CITY OF MARLBOROUGH MEETING POSTING

Meeting: Planning Board
Date: January 25, 2021
Time: 7:00 PM
Location: REMOTE MEETING NOTICE

Subject: Four-Lot Subdivision, 76 Broad Street, Marlborough, MA
Response to Engineering Division review comments

C2

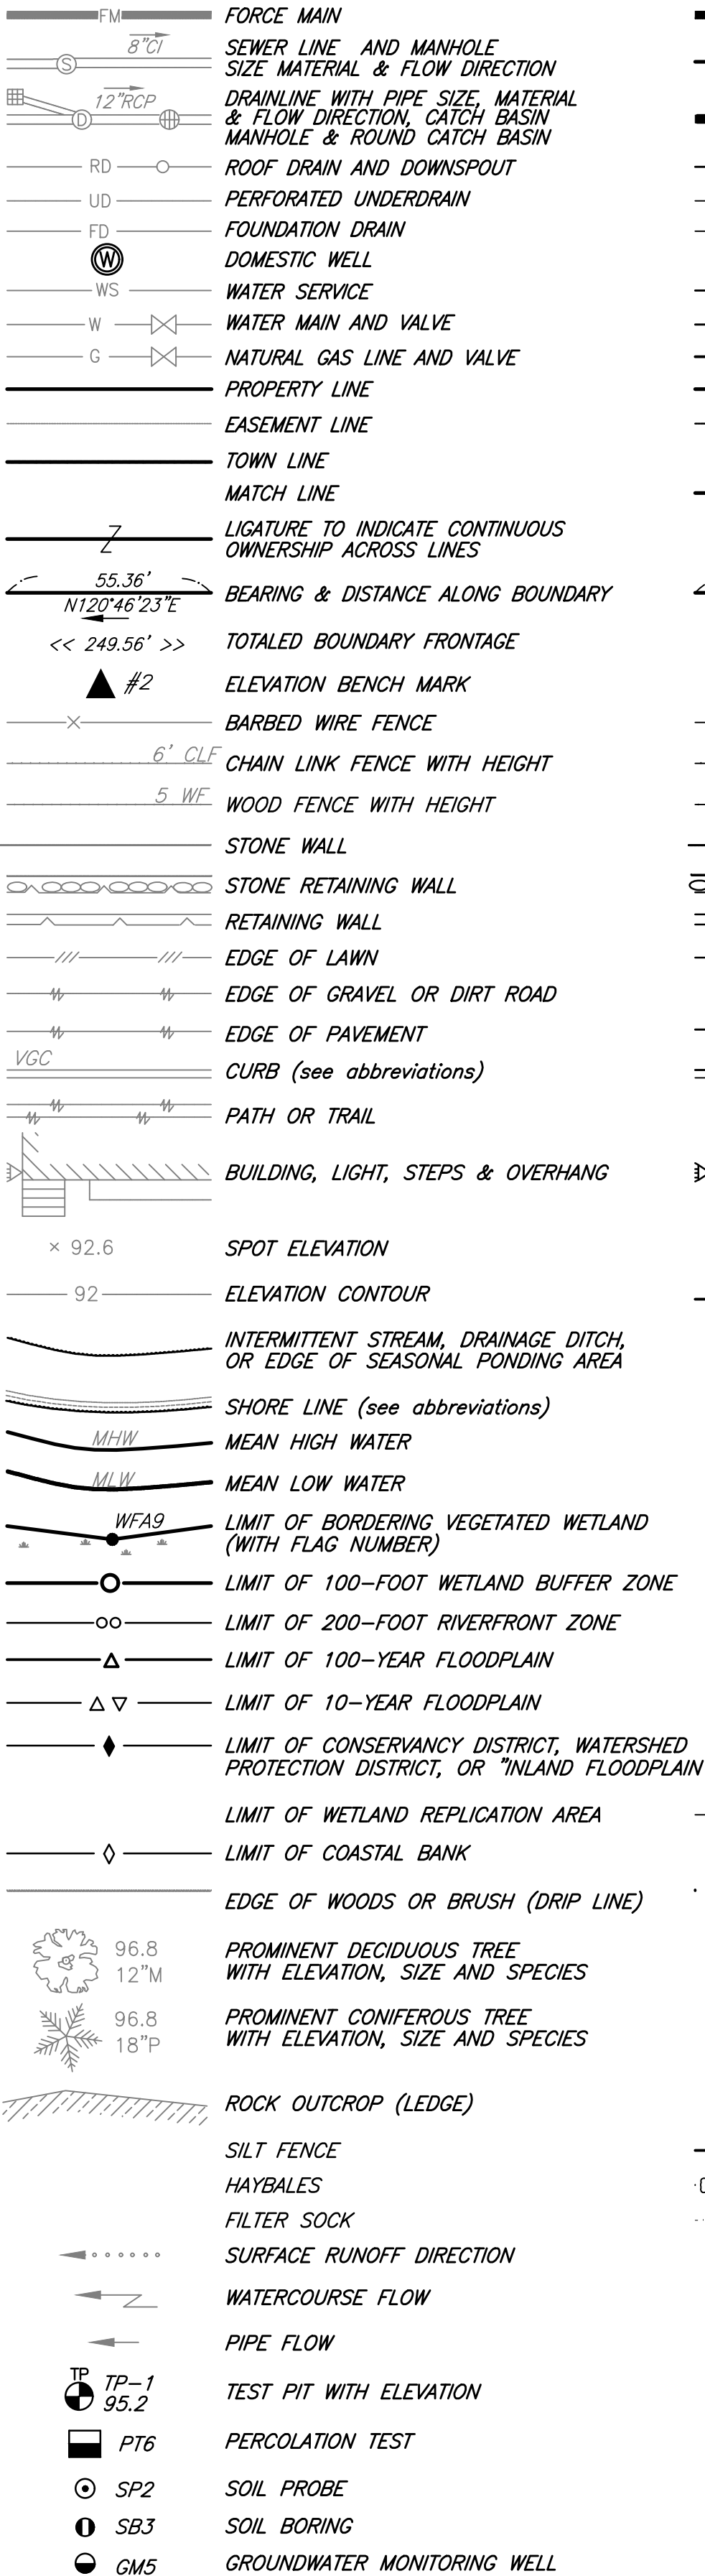
- “19. The proposed site development for all proposed lots are shown schematically only. Individual Site Plans shall be submitted for approval prior to the development of proposed lots. Each lot proposed shall contain up to one(1) Two-Family dwelling per lot maximum.”. “... as of right” should be added to the sentence along with the following sentence: “Multi-family dwellings containing three or more dwelling units on a single lot are allowed in a Residence C Zone with a Special Permit issued by the Marlborough City Council provided that the

Response: Note 19 on Sheet C2 has been revised.

<h1 style="text-align: center;">DEFINITIVE SUBDIVISION PLAN</h1>	
PLOT DATE: Jan 20, 2021 12:57 pm	
DWG: 13820-DS R3.dwg LAYOUT: DS SHEET: 1 OF 1	<h1 style="font-size: 48px;">DS</h1>
PROJECT NO.:	<h1 style="font-size: 24px;">13820</h1>

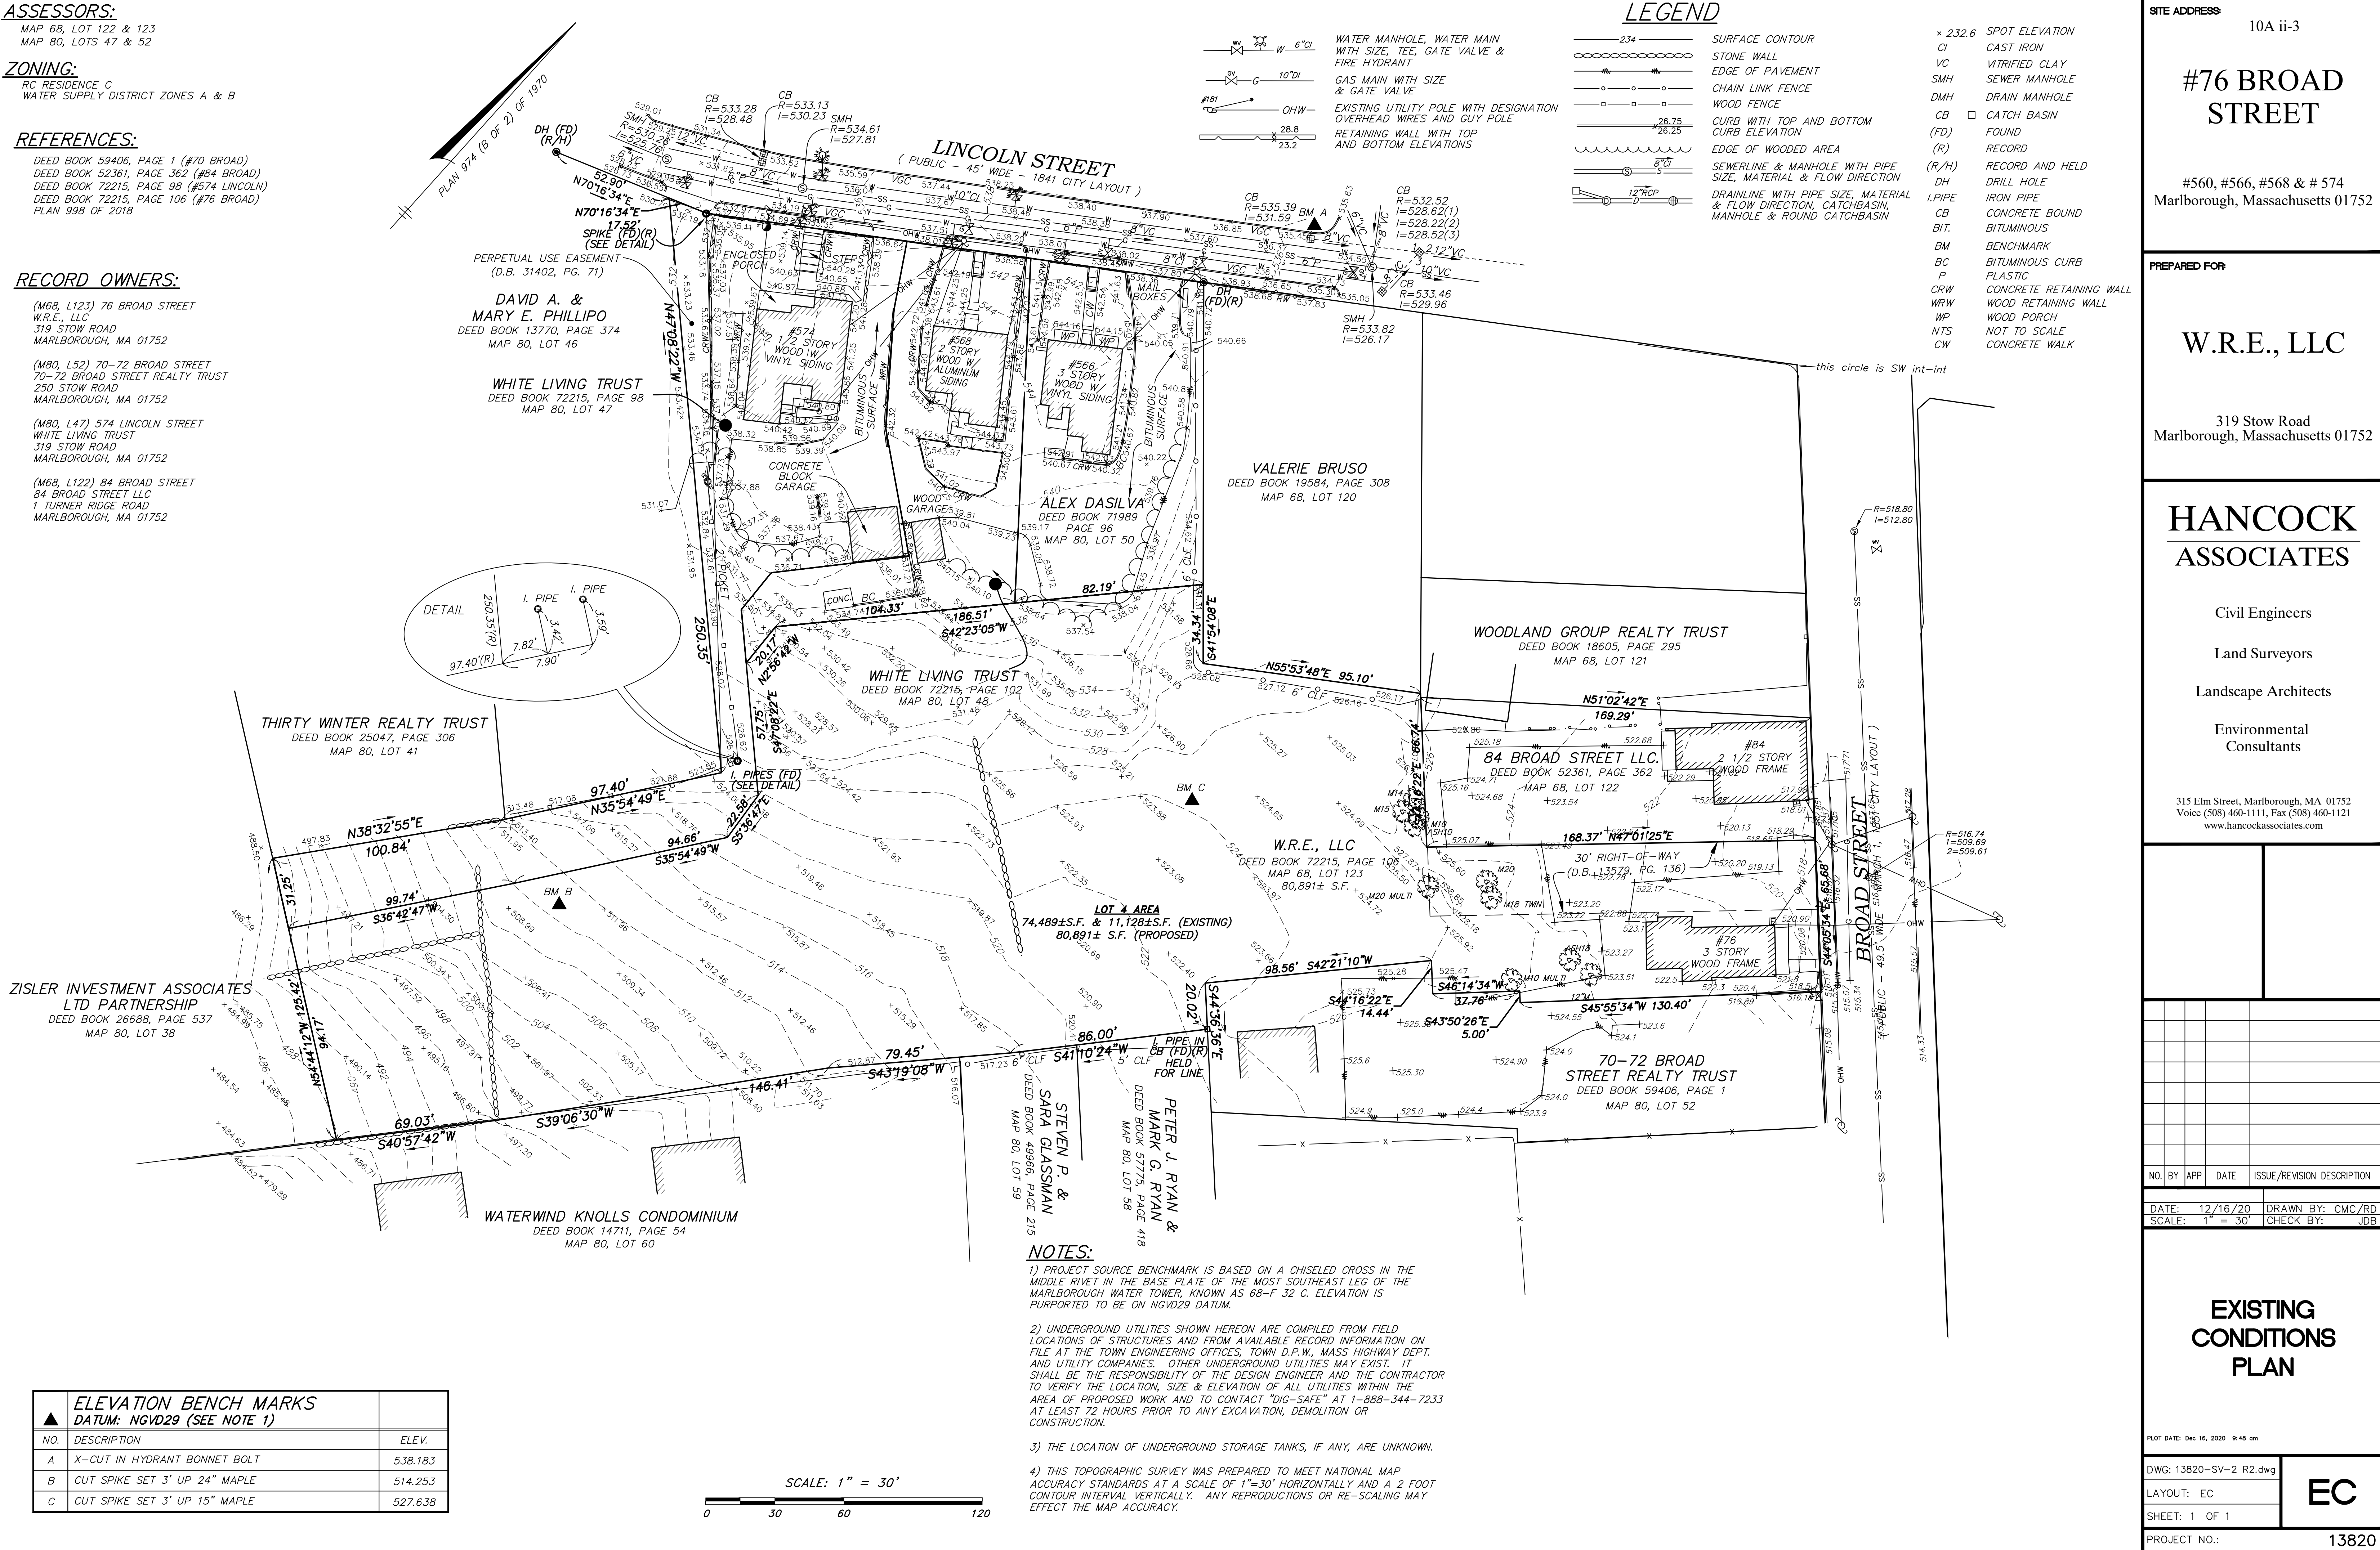
- Notes: 3) This Lotting Plan is Sheet 4 of 11 in a Definitive Subdivision Plan set. The revised plans have 12 sheets in the Definitive Subdivision Plan set.

- Notes: 4) See Sheet 1 of Definitive Subdivision Plan set in town file for requested and approved waivers – the reference to Marlborough should be a "city".

- Assessor's Reference should also note the owners of the properties. The property owners of Map 68 Parcel 122 and Map 80 Parcel 47 and 52 were not noted on the original Form C – Application for Approval of Definitive Plan. A letter from each of the property owners stating their permission for the use of their property in the design/use of the Definitive Subdivision Plan submission is required. Proof of the legal document for any required easements for the Definitive Plan must be shown to the Planning Board prior to endorsement of the Definitive plan submission.

- The proposed location of the crosswalk and curbing and utility pole modifications along the intersection roundings at Broad Street eliminate the access for both properties at #70-#72 Broad Street and #84 Broad Street. The Definitive Subdivision Plan will need to show a construction easement on both #70-#72 Broad Street and #84 Broad Street over the area that will be affected by the change in the driveway location and changes to the parking areas for each of these two lots.

- The areas for the Proposed Drainage Easement should be noted on the plan.

- The Maintenance Access, shown on Plan C6 Grading and Drainage Plan, should be in the easements shown on this sheet.

- The plan notation "See Detail "D" – no detail is shown.

Response: Note 3 has been revised.

Response: Note 4 has been revised.

Response: Record owners for involved properties have been added. A letter will be supplied to the Planning Department before the end of the review period.

Response: Two (2) construction easements have been added.

Response: Areas have been added to the drainage easement callouts.

Response: The proposed maintenance access has been added to this plan.

Response: This note has been removed.

GRADING AND DRAINAGE PLAN

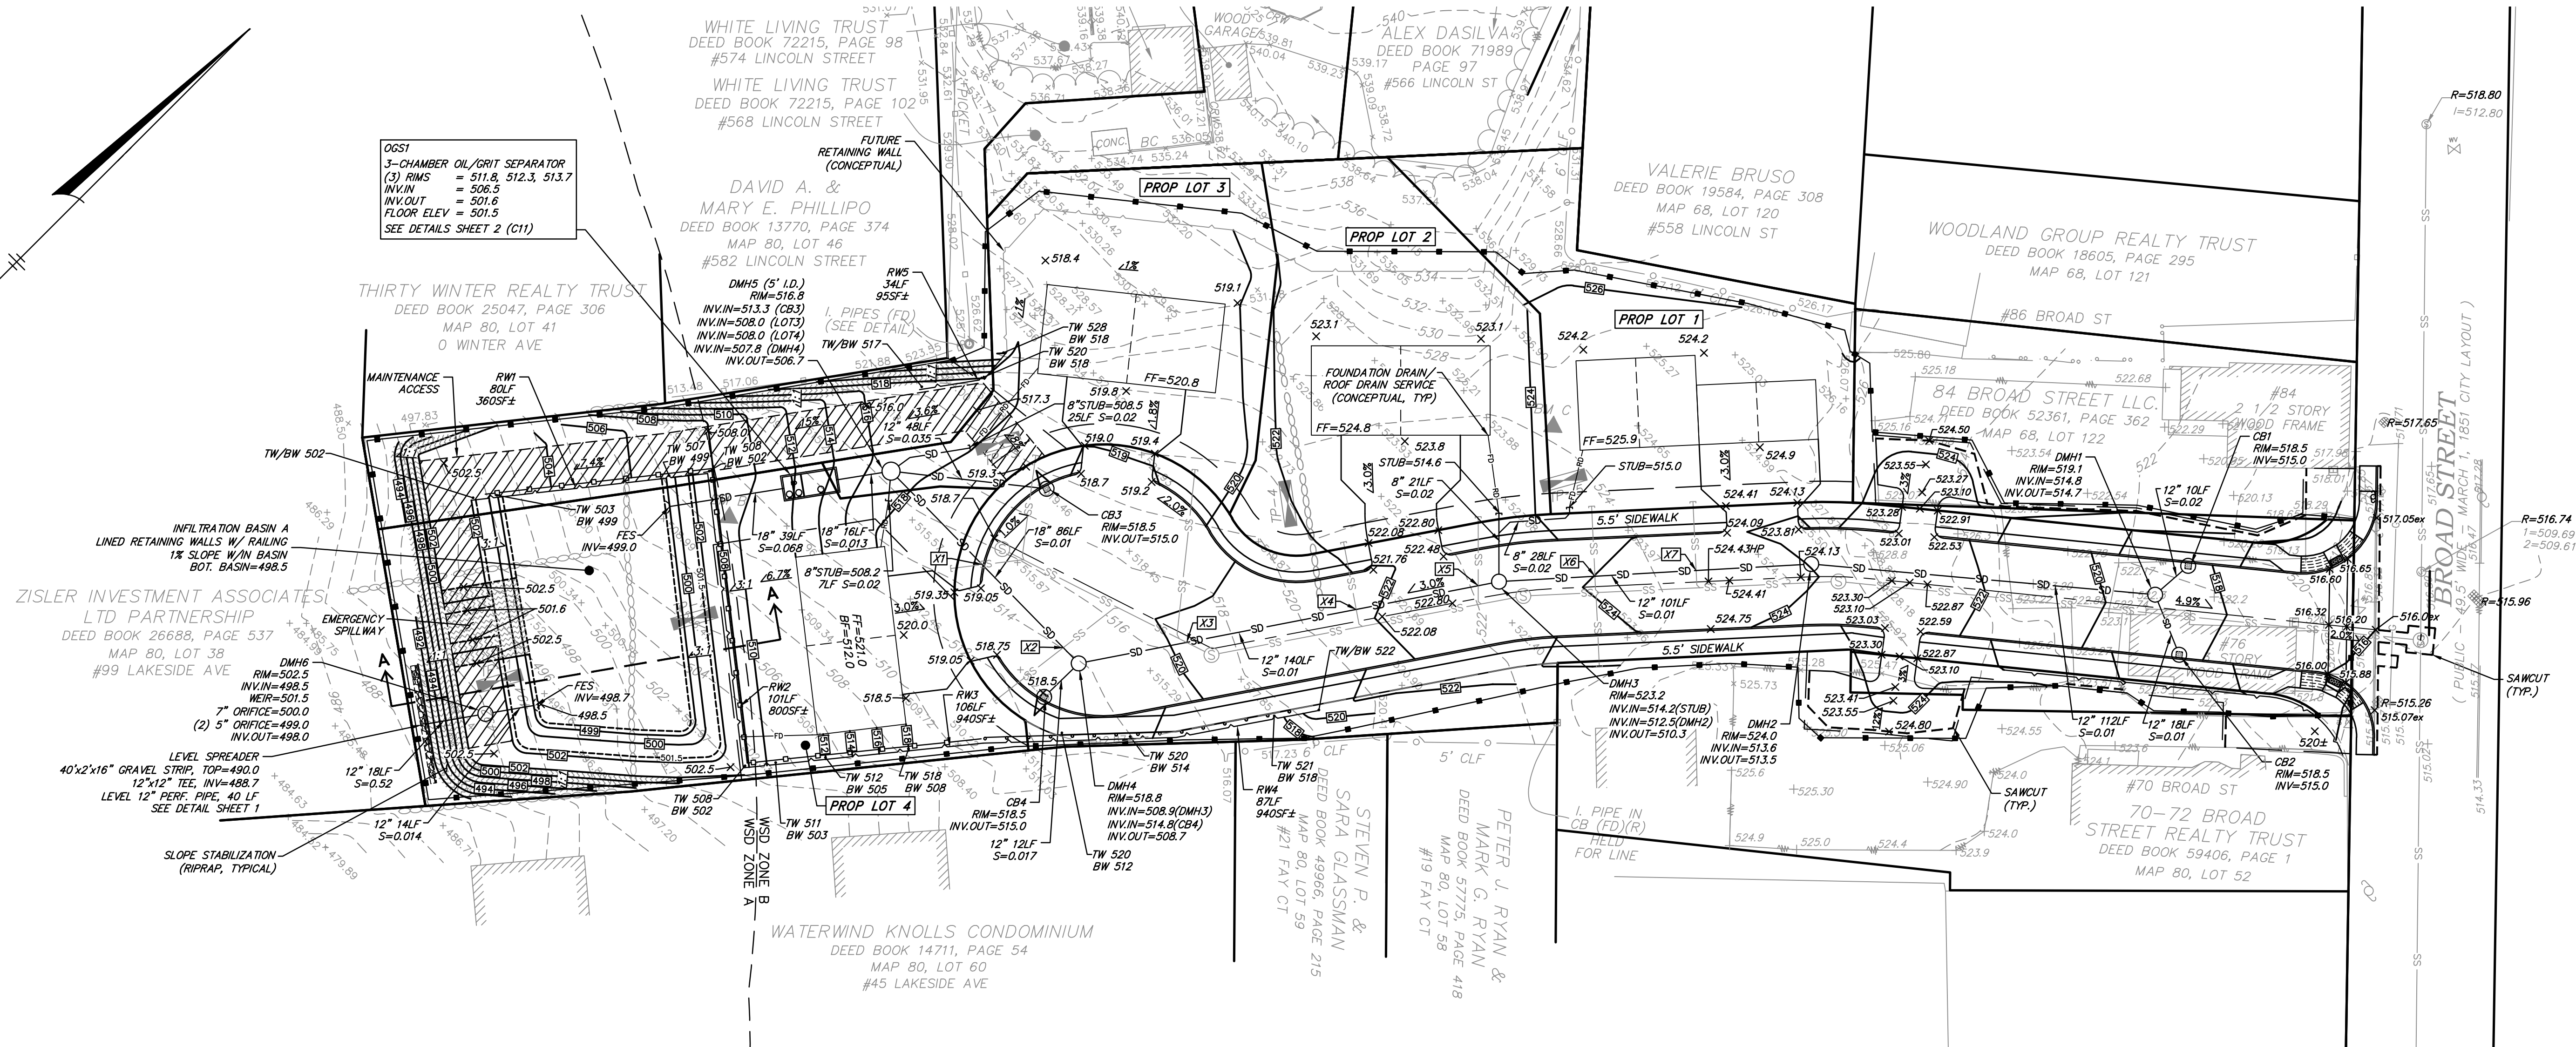
- Driveway profiles for the new access to #70-#72 Broad Street and #84 Broad Sheet should be shown, compliant with §650-48, Off-street parking and §650-49, Driveway and curb cuts. Modify the sawcut line on Sheet C5 Layout & Materials Plan accordingly.

- The notes listed in Grading and Drainage Notes should be replaced with the notation as stated in the comment for Sheet C2 – Note #19.

Response: Driveway profiles for both driveways have been added to Sheet C8. The sawcut lines on Sheet C5 have been revised.

Response: The notes have been revised to agree with Note 19 on Sheet C2.

Response: Swapping the drain line and sewer main would require relocation of the water line and other utilities, and lead to potential crossing issues elsewhere. The storm drain and sewer line design shown satisfies all crossings as listed.

Response: Note 3 has been added to Sheet C6.
